**Addendum**

Mahopac Central School District  
Mahopac, New York

Reconstruction at  
Mahopac High School  
Mahopac Middle School  
Mahopac Falls Schools  
Bus Garage  
New Pump House

BID Addendum No. 1  
to  
Drawings and Project Manual

2 Basement Cafeteria & Kitchen Power & Communications Plan - Area B  
1/8" = 1'-0"

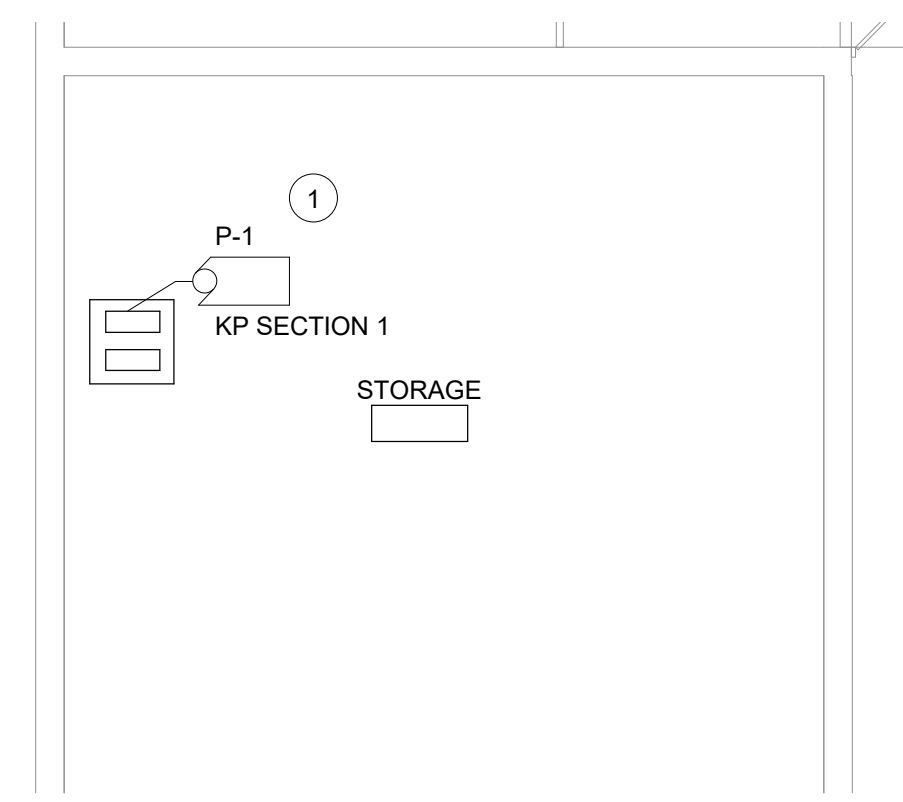
-----  
Question Pertains to: **Basement Cafe/ Kitchen Devices**

Drawing Number: **AE 161**  
Plan Area:  
Room Number: **247**  
Drawing Detail Number:  
Specification Section:

*No Answer to Door Holder Question*

**AE200**

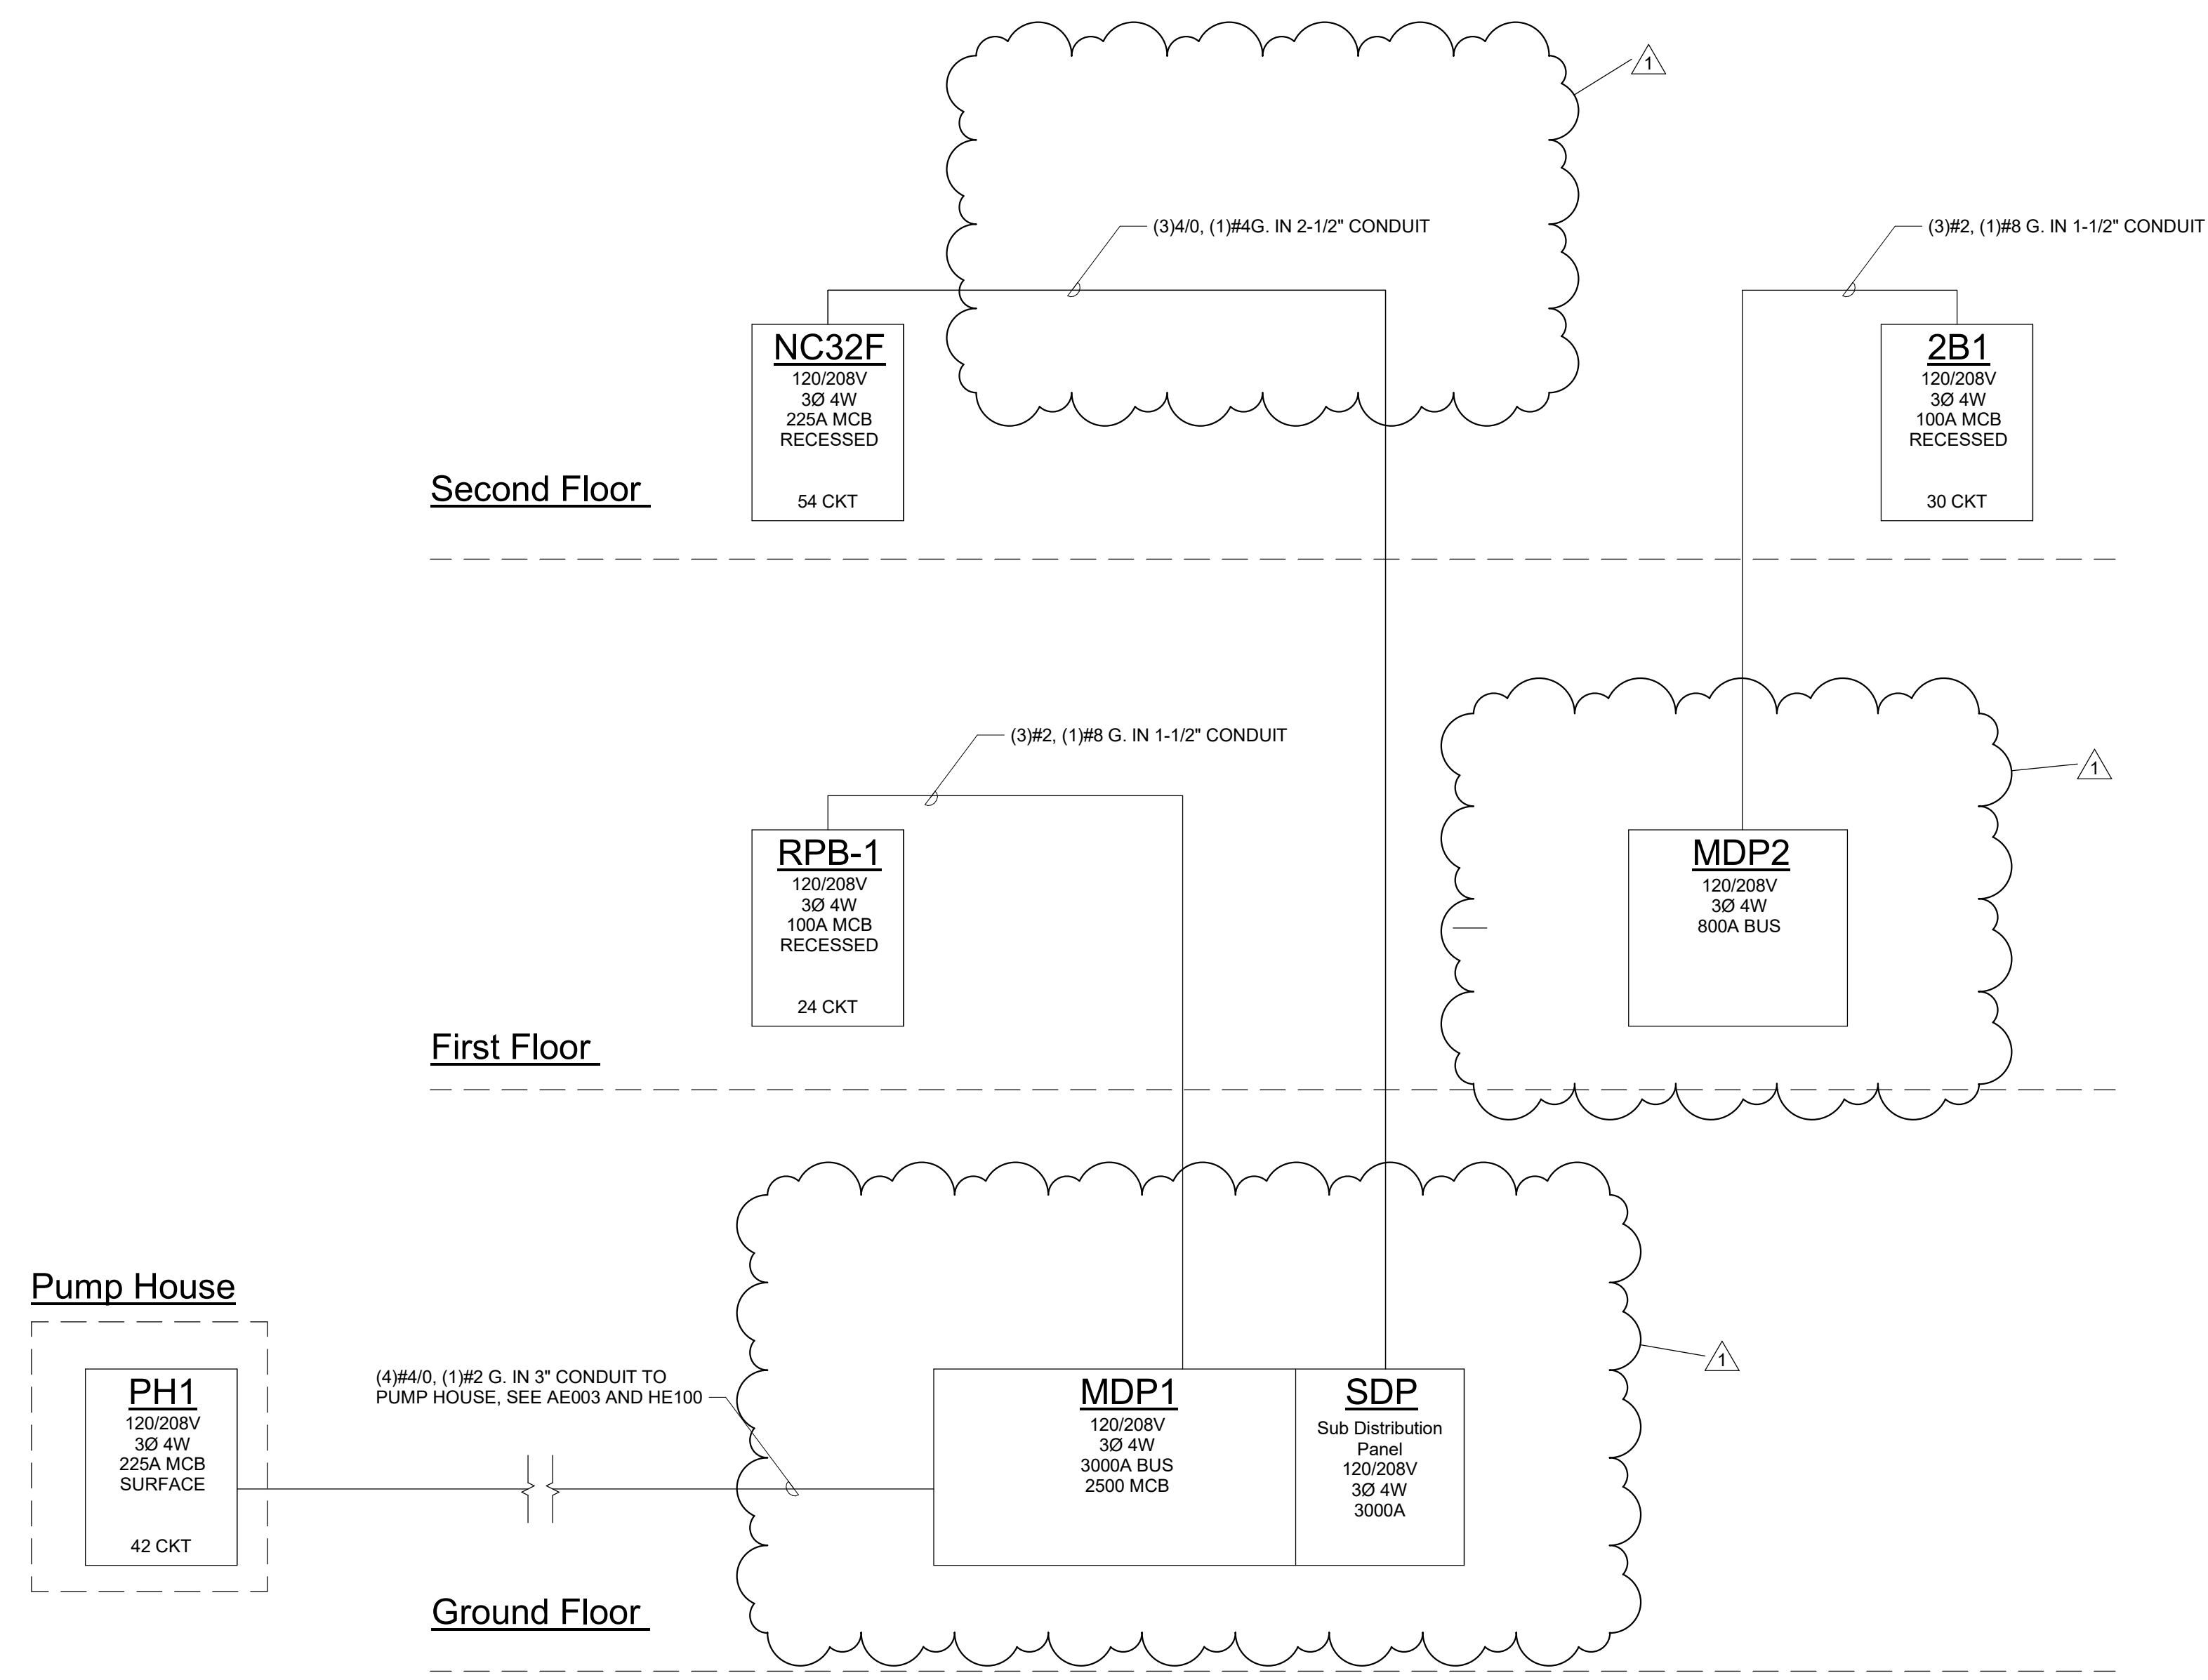
**Question: (Please be specific)**

Please clarify the intent of the fire alarm control panels shown on drawing AE200. The drawings appear to show 3 panels and we are removing 1 and replacing it to accommodate the new speaker/strobe devices. Upon a site visit, it appears that there are only 2 panels, both Notifier. Are we just adding a 3rd Notifier panel for these new devices and everything else stays as is?

- 1 CONNECT NEW FIRE ALARM DEVICES TO HONEYWELL 4040 FIRE ALARM PANEL. THE EXISTING SYSTEM IS NOTIFIER.
